MIL-M-28787/211A(SH)
AMENDMENT 2
23 March 1992

MODULES, STANDARD ELECTRONIC

TEST POINT, ISOLATED, MISCELLANEOUS, KEY CODE FZJ

FIGURE 1 EZJ module function diagram, isolation test point

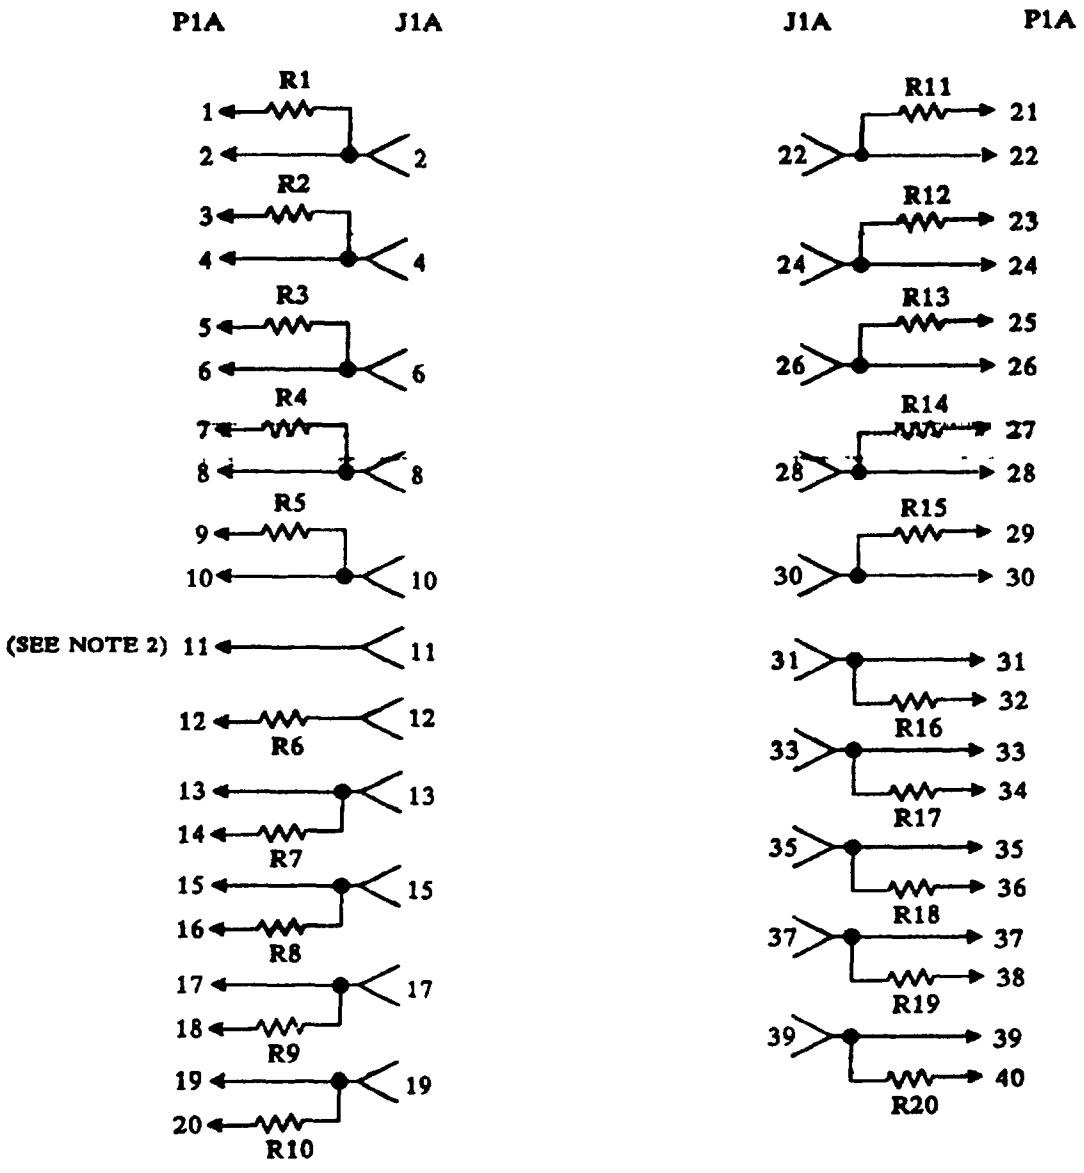
FIGURE 1: Delete and substitute new figure 1 as printed on page 3 of this amendment.
